Westinghouse Response to NRC Observation 3-3 (Non-Proprietary)

OBS 3-3

Demonstrate with supporting analyses and discussion that the thermal models discussed in the thermal chapter accurately model the thermal-related phenomena for steady-state storage and transient operations.

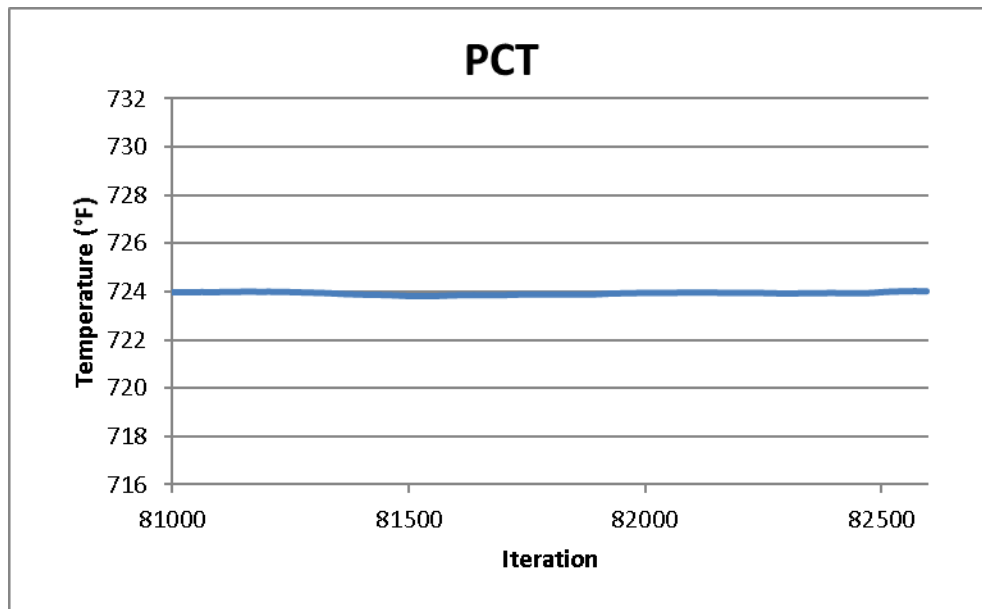
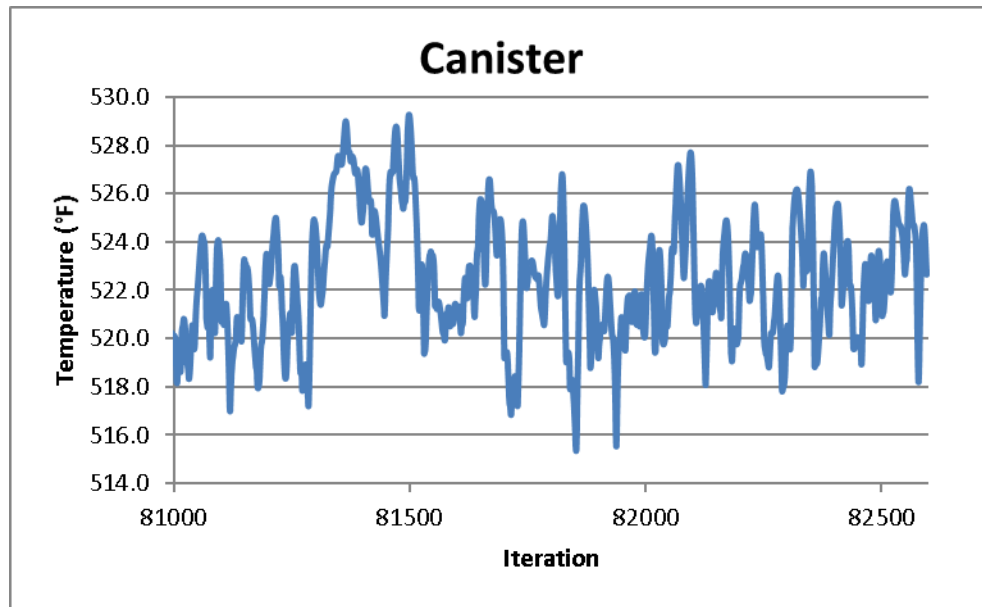
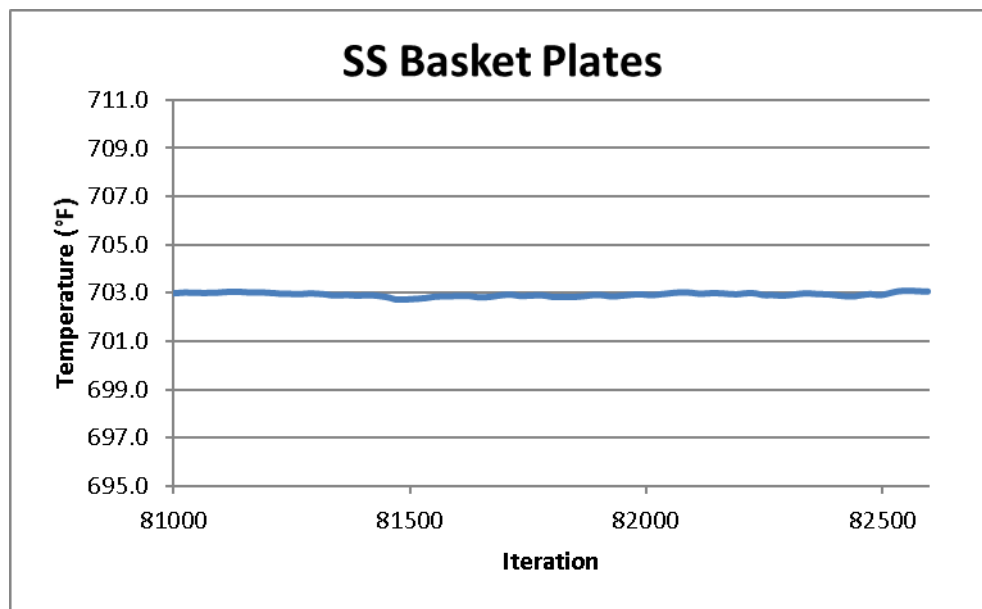
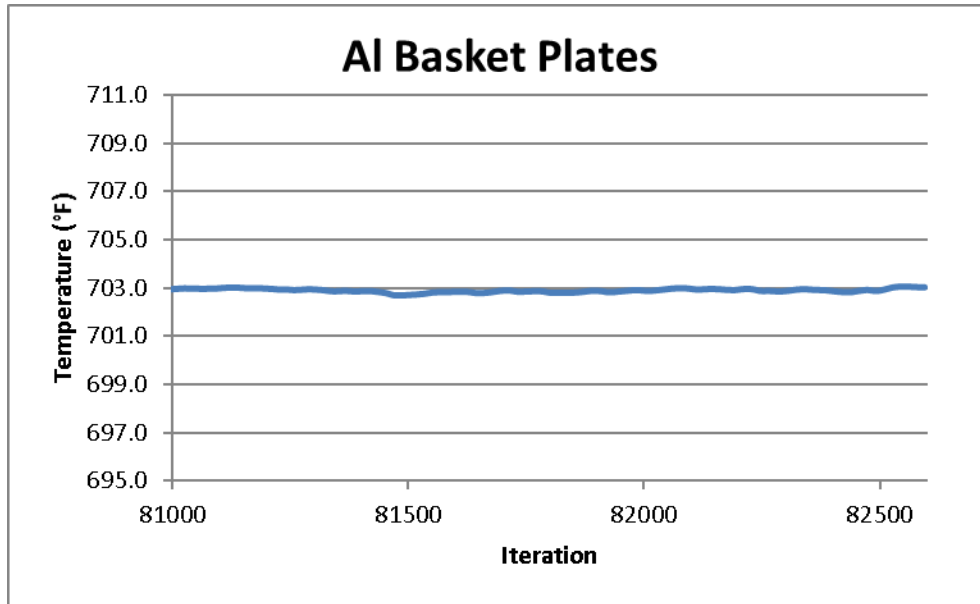
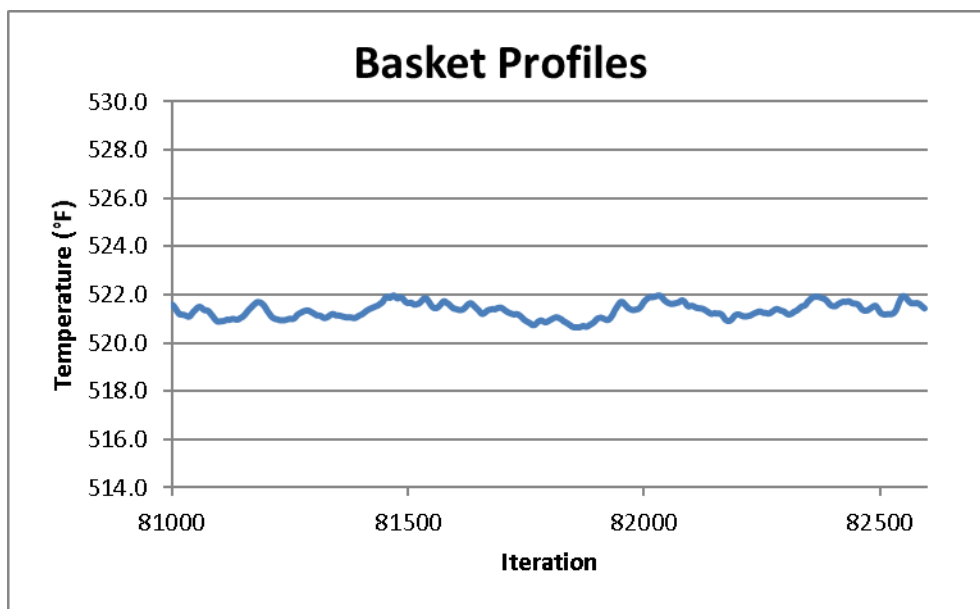
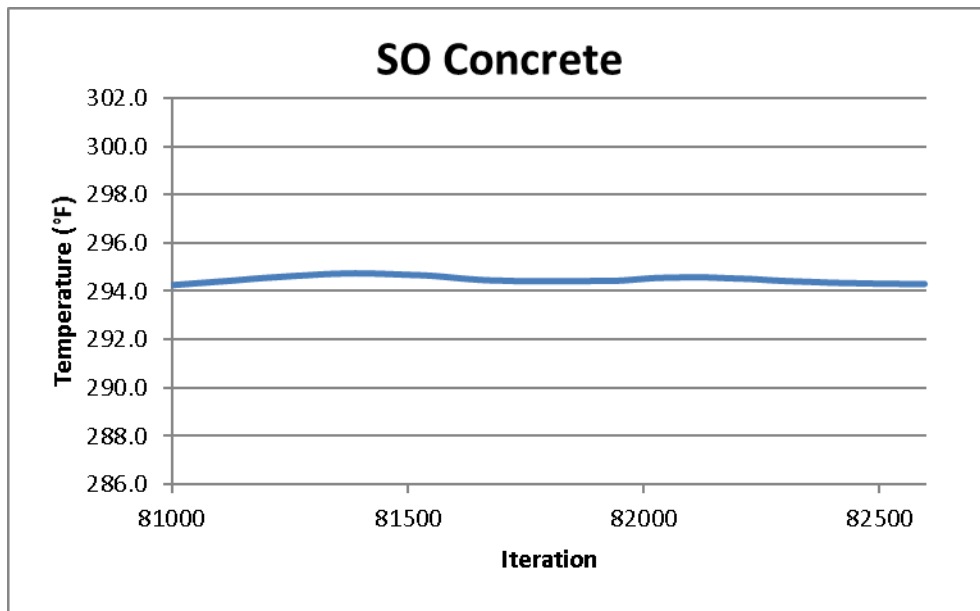
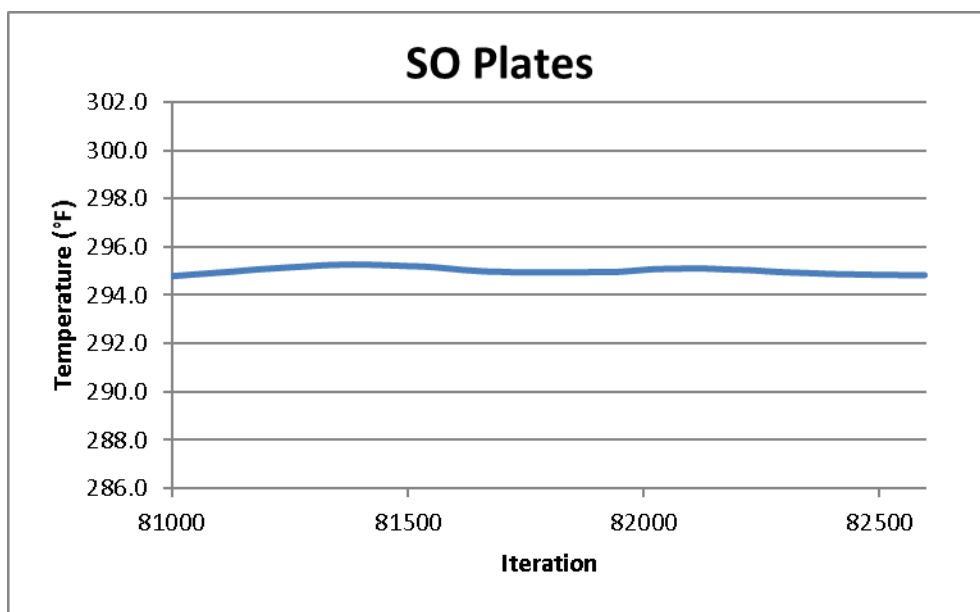
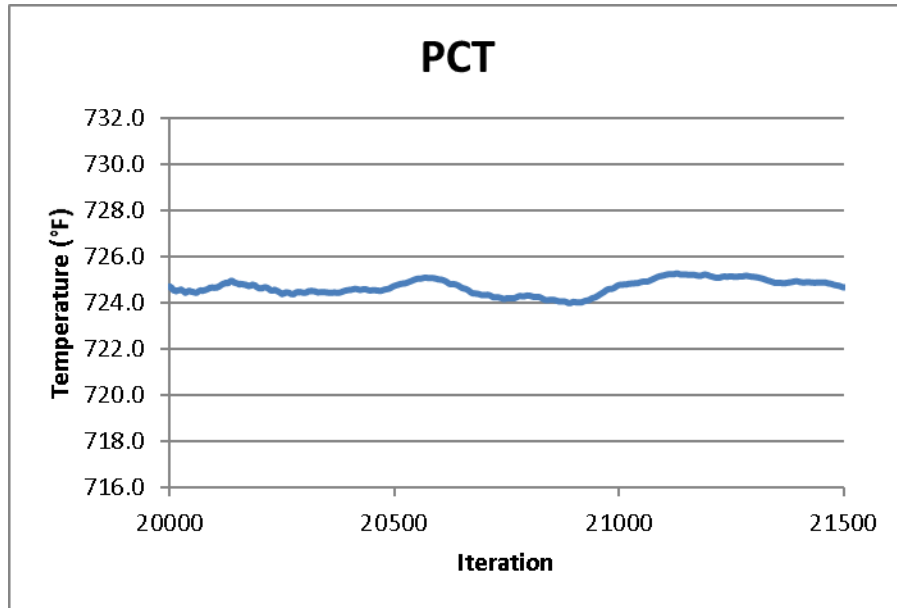
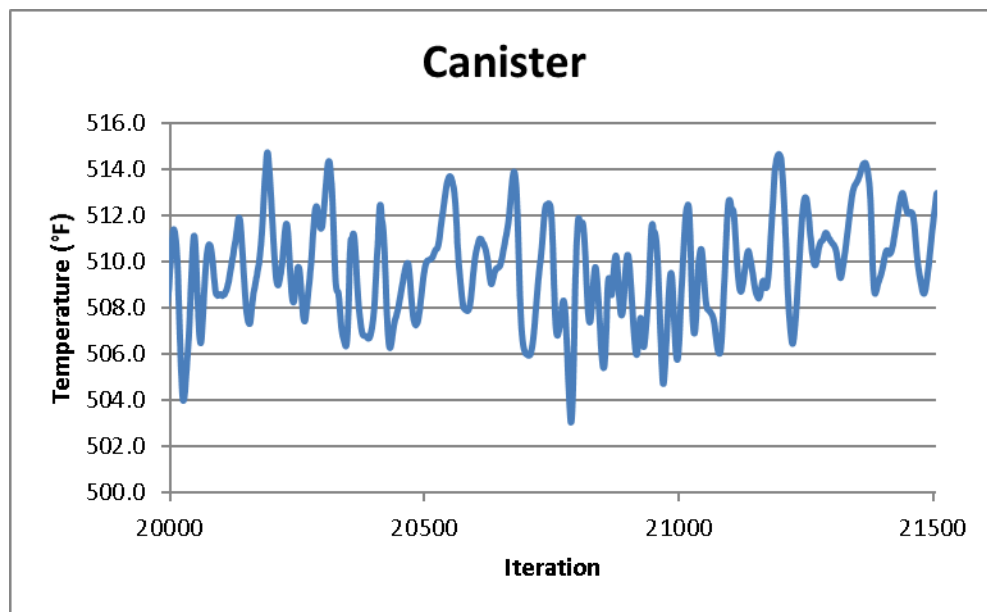
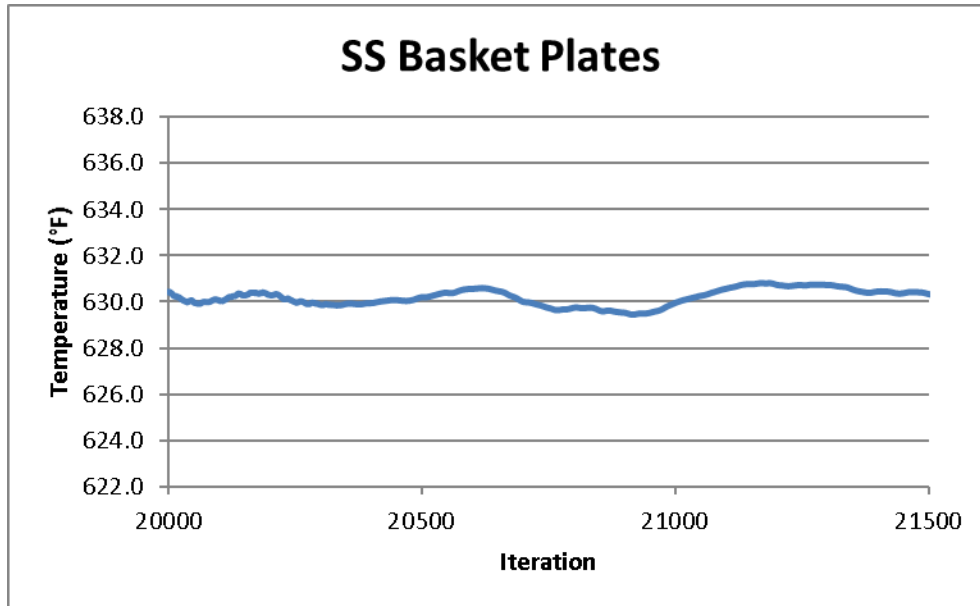
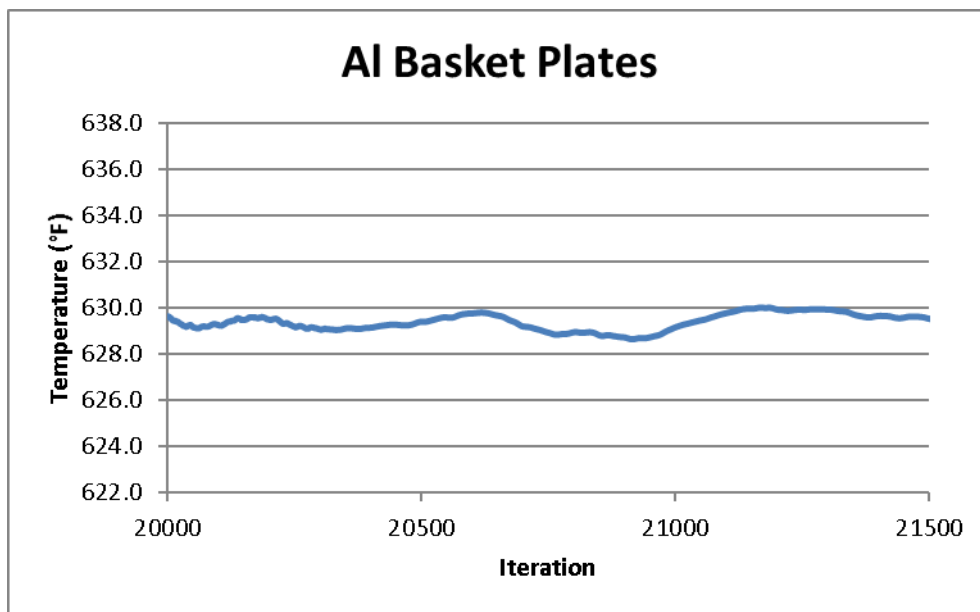
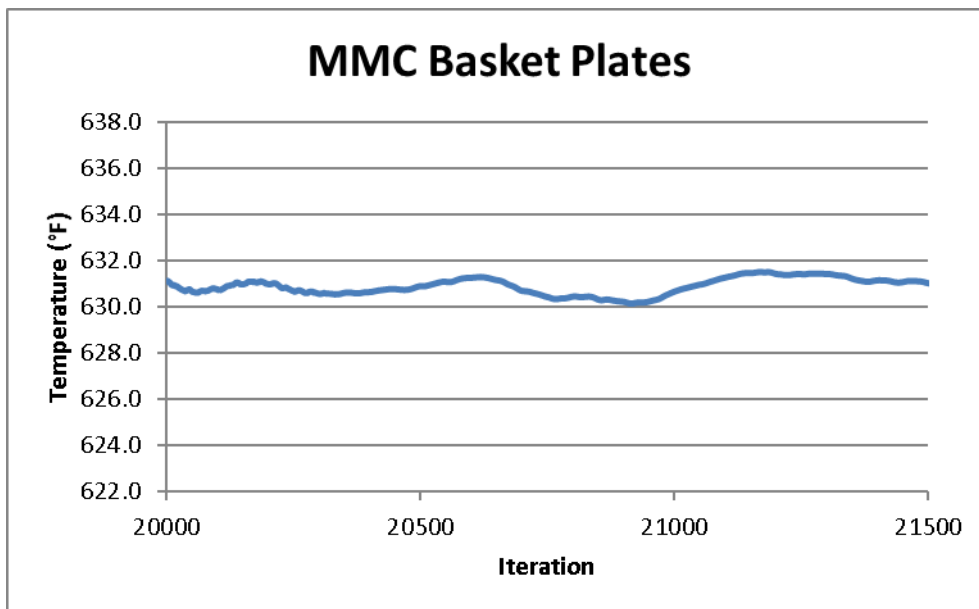
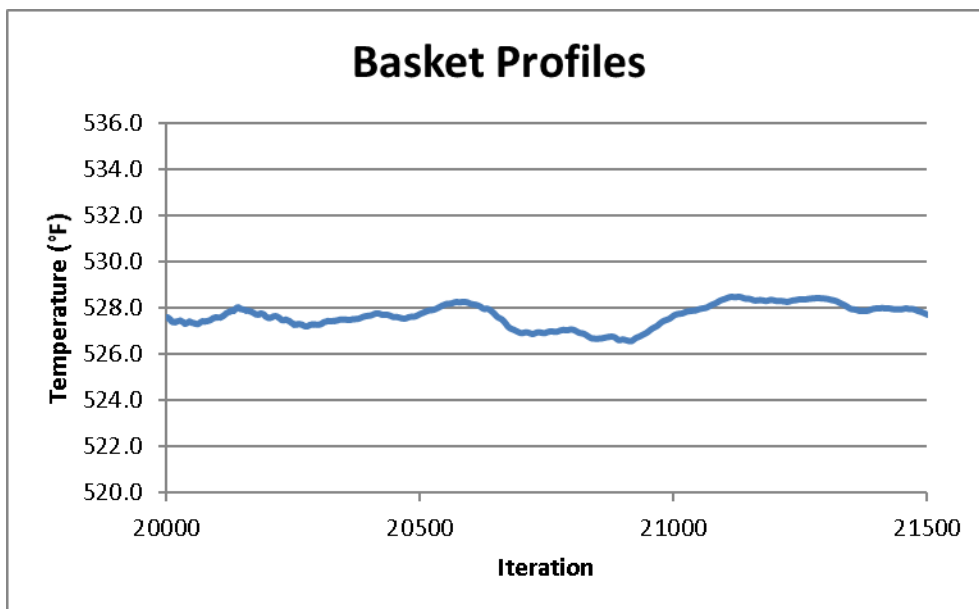
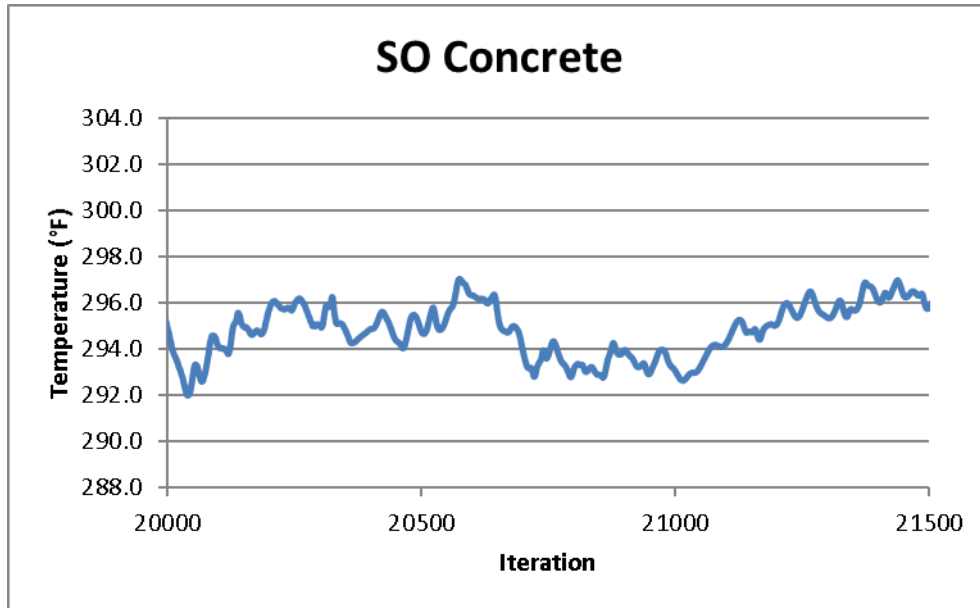
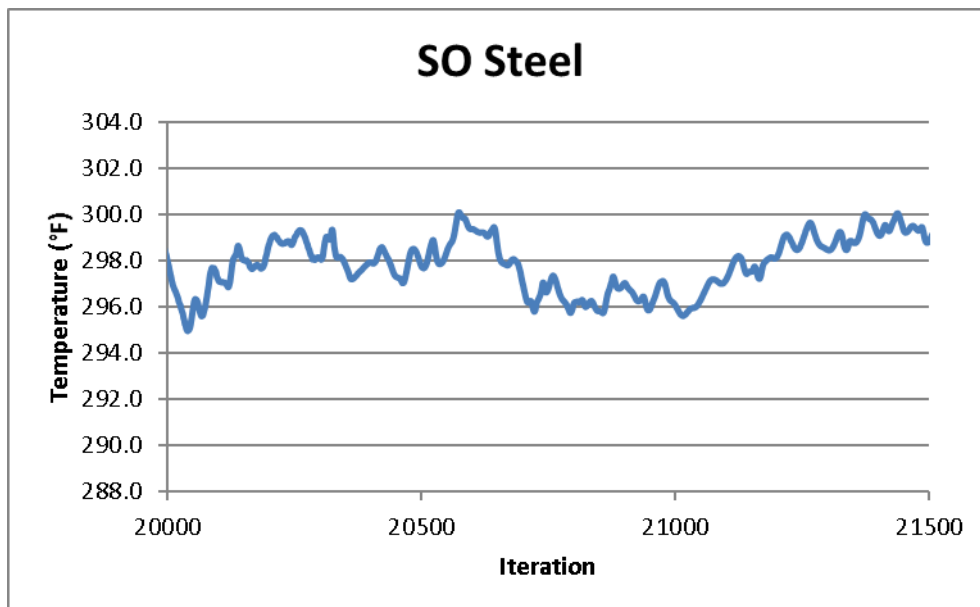
- a. It is noted in the thermal analysis that the PCT results for canister W37 (45 kW) and canister W21H (65 kW) were at similar temperatures. The chapter does not demonstrate how the unique thermal aspects associated with the W21H canister, with much greater power density (kW/m³), would have resulted in a similar PCT as the lower power density canister, nor does it provide input, convergence, energy balances, and solution values to confirm performance of the two canister models.

The computations (residuals) in the different Structures, Systems and Components (SSCs) were monitored throughout the code execution to insure convergence. Since natural convection is a transient process by nature, some variability in the residuals is to be expected. The monitored values are the maximum temperatures for each SSC. Figure 5 to Figure 11 show the results for the SSC using the W37 canister in W180 storage cask base case (zonal loading pattern 1 with DBF1). Figure 12 to Figure 19 show the results for the SSC using the W21H canister in W180 storage cask base case (zonal loading pattern 1 with DBF1).

All the values reported have a small temperature fluctuations with the exception of the canister temperatures. In this component, the turbulent flow of the helium below the area in which the maximum temperatures for the canisters are obtained induce some natural variability in the calculated results. Figure 20 gives some indications of the vortexes generated by the helium in the area of interest. However, even these fluctuations are not extreme, and the results show an adequate, engineering level of convergence.

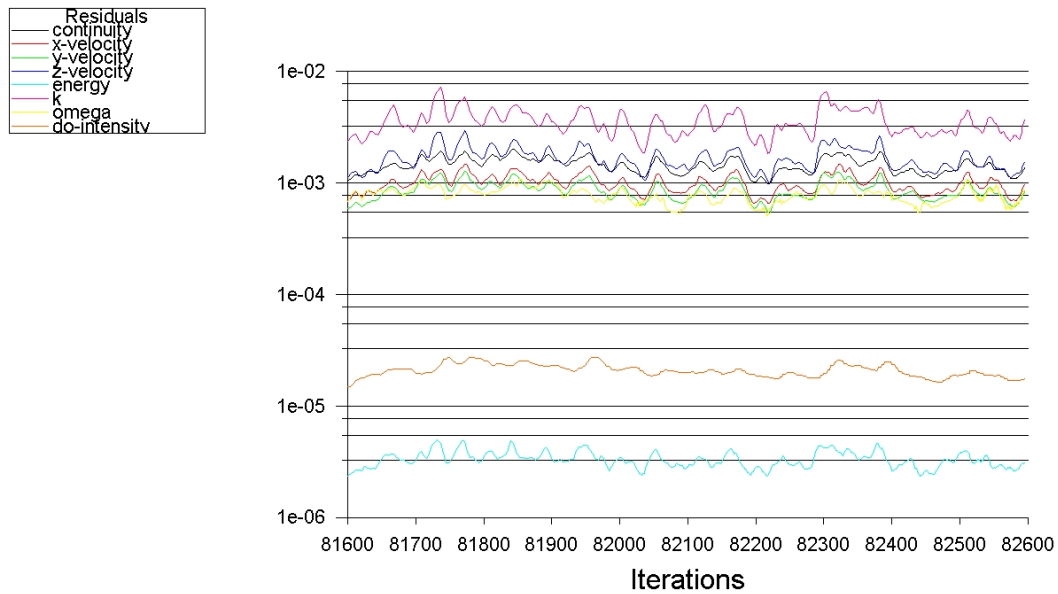
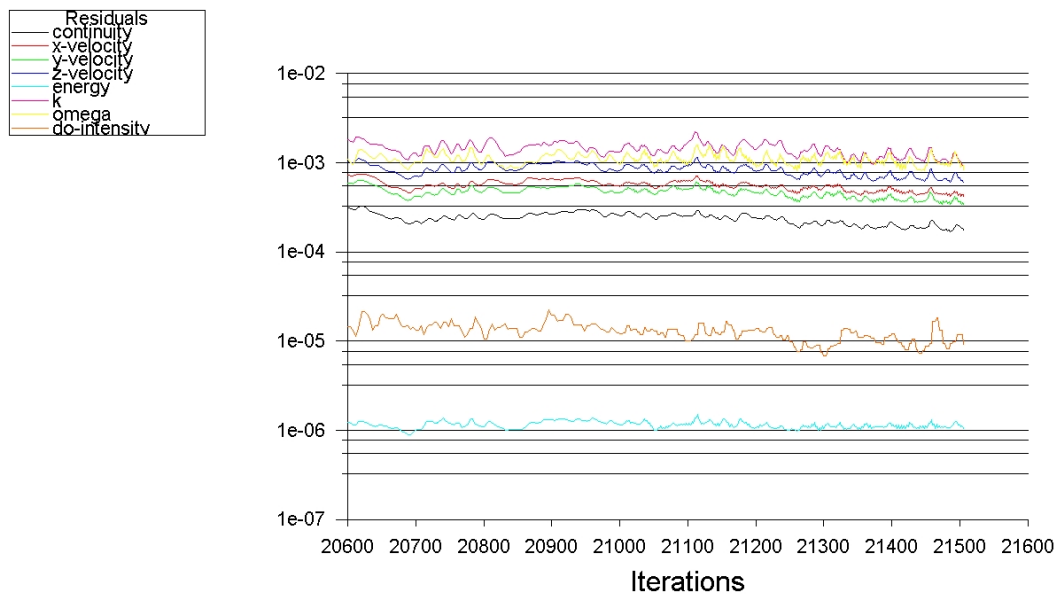
- b. There was limited information and validation associated with the “equivalence” between the (transient) two-dimensional and three-dimensional thermal models, recognizing that a steady-state comparison between 2D and 3D models would not explicitly demonstrate appropriate consideration of thermal mass effects. Using appropriate models are needed to ensure bounding temperatures on important to safety components during steady-state and transient operations.

The CFD models have been run until they converged. This means that the solution no longer varies with additional iterations (as shown in the previous figures for the SSC) and that the residuals are below a prescribed root mean square (RMS) level (10^{-3} for continuity equations and 10^{-6} for energy equations). In reality, as stated in NUREG/CR-7260, *“some solutions are better behaved than others. ... Some solutions are much “noisier,” and their solution can vary significantly within a range of values.”* In the SENTRY system is identified a variation *“due to physically based unsteady flow patterns in the steady-state simulation”* as shown in Figure 20. Also, the vorticity in the inlet vent have an impact on the residuals. With the high resolution of the grid used for this analysis (as required by the SST k- ω approach), the model captures very well the unsteady behavior at the vent inlet. This unsteady behavior makes it more challenging

to meet the convergence criteria. The residuals for the base case using the W37 and W21H canisters are shown in Figure 21 and Figure 22, respectively.
